Environmental Planning Commission

Agenda Number: 3
Project #: 2021-005301
Case #: SI-2021-00452
Hearing Date: July 15, 2021

Supplemental Staff Report

**RE: DUTCH BROTHERS MAJOR AMENDMENT 7 BAR- EPC
RESPONSE TO COMMENTS PR-2021-005301/SI-2021-00452
3615 HWY 528, ALBUQUERQUE NM 87114
ZONE ATLAS PAGE A-14-Z**

GRADING AND DRAINAGE DETAILS

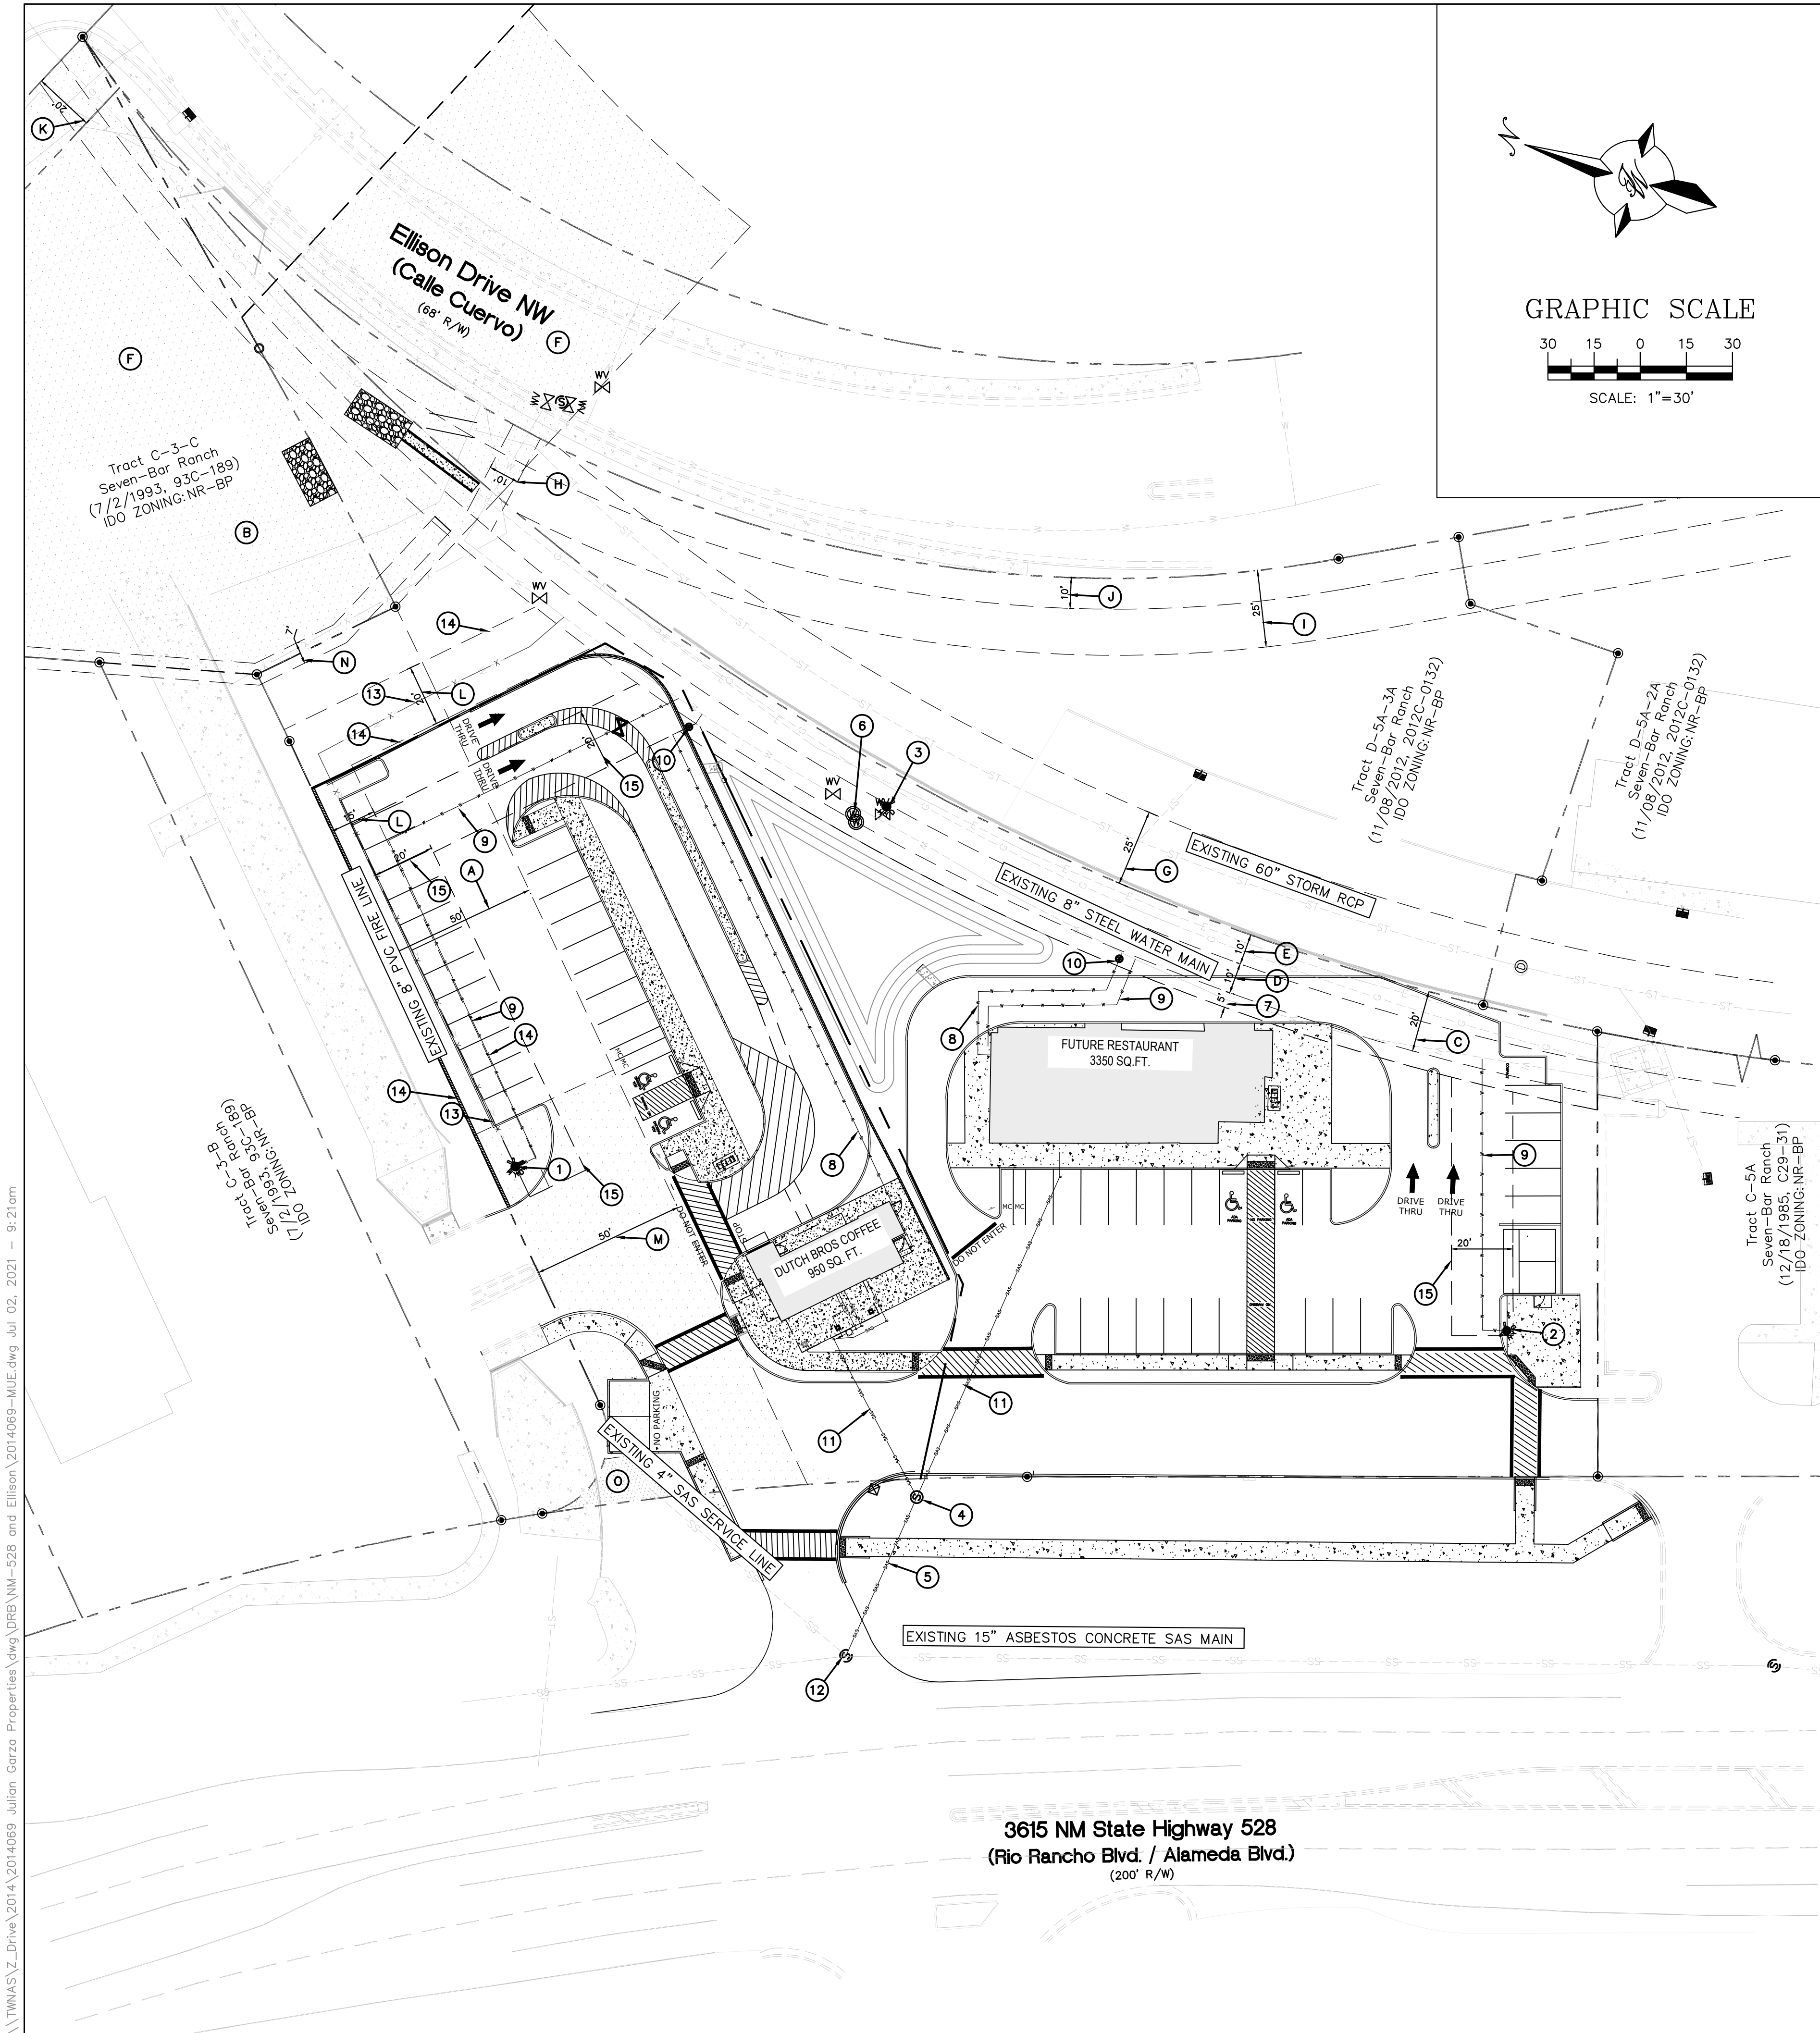
B. A curb notch detail shall be provided.

Response: Curb notch detail provided on sheet C5.

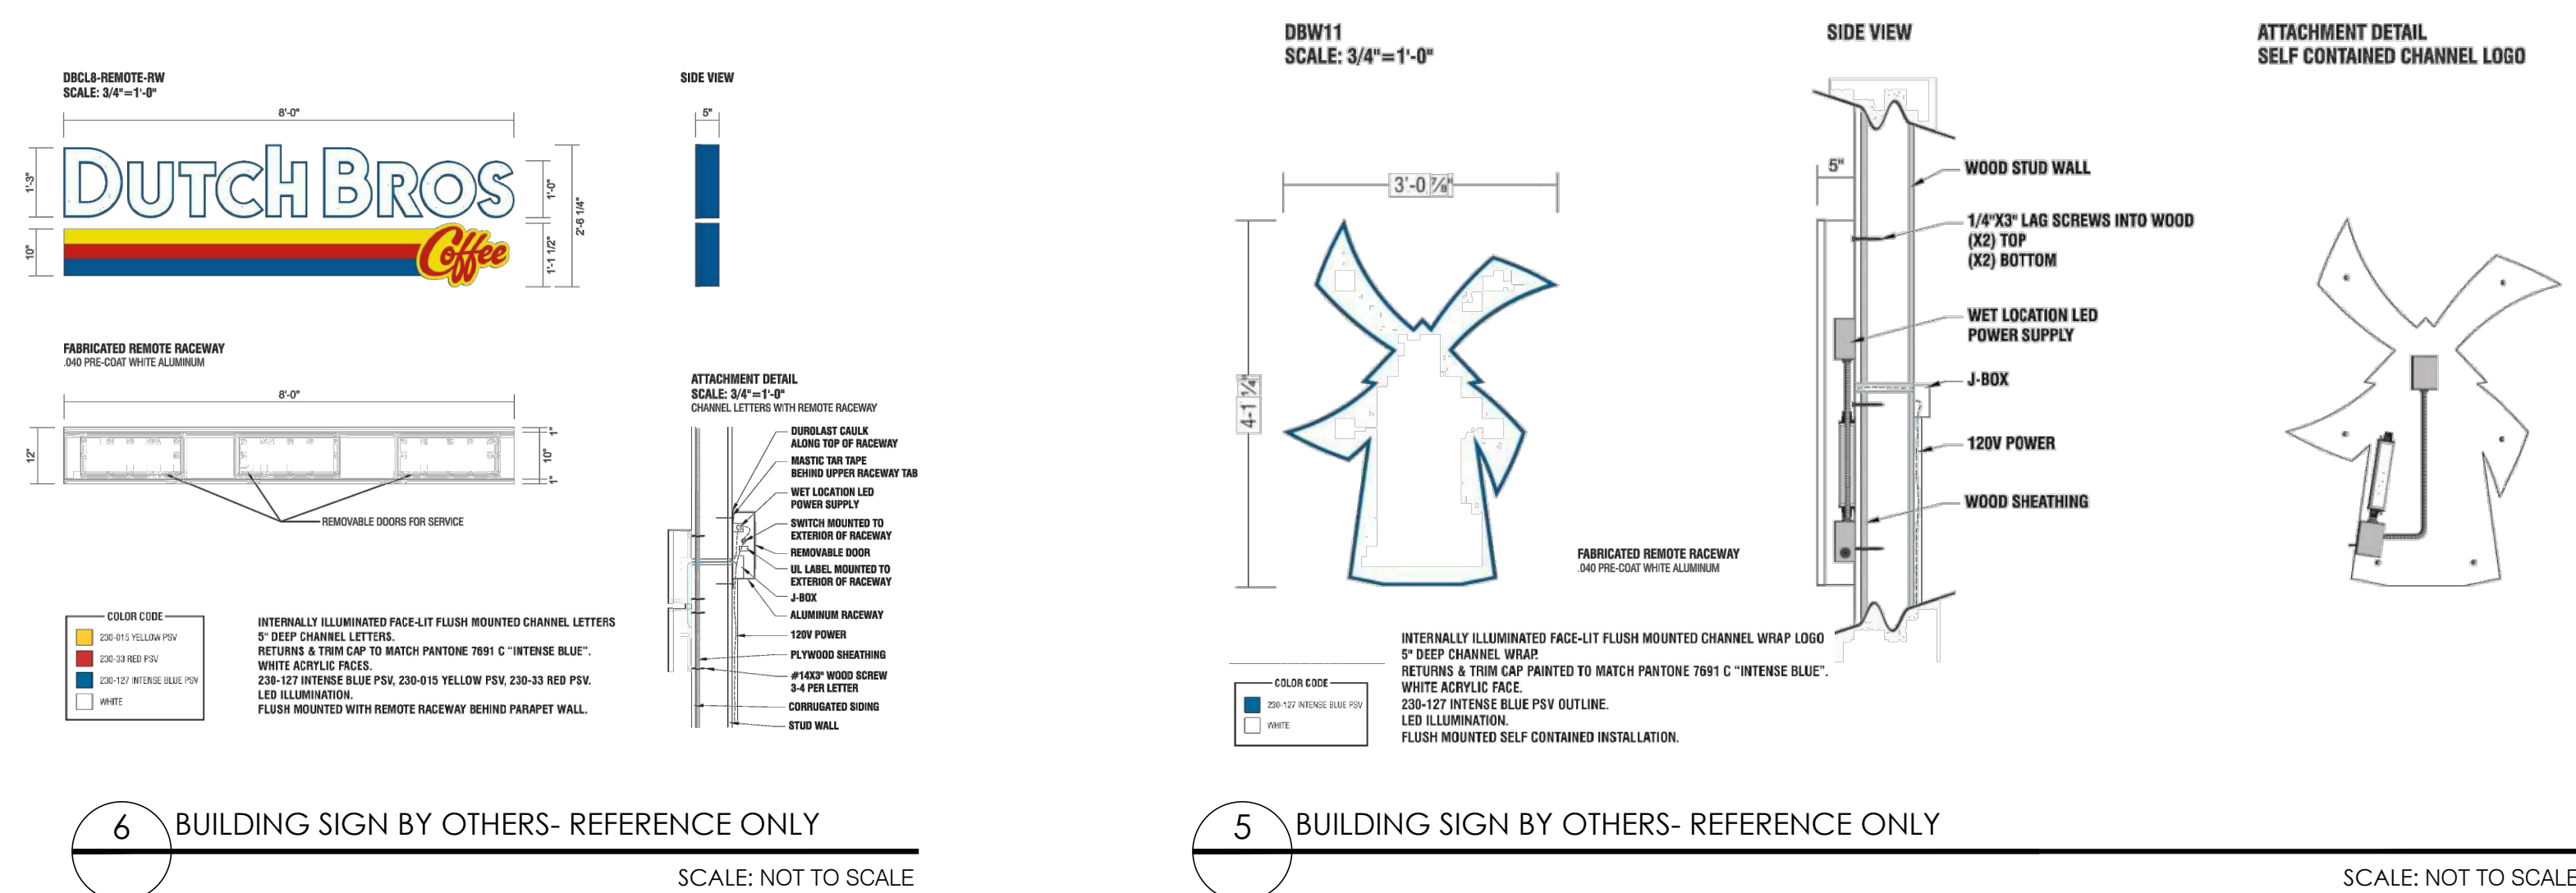
- C. The site plan shall indicate if the existing water services are to be used.

Response: Acknowledged, as shown on the utility plan sheet C6 each lot has separate private sanitary sewer services.

Response: Master utility plan sheet C6 indicates that the existing services shall be terminated and uninstalled per ABCWUA standard specs.
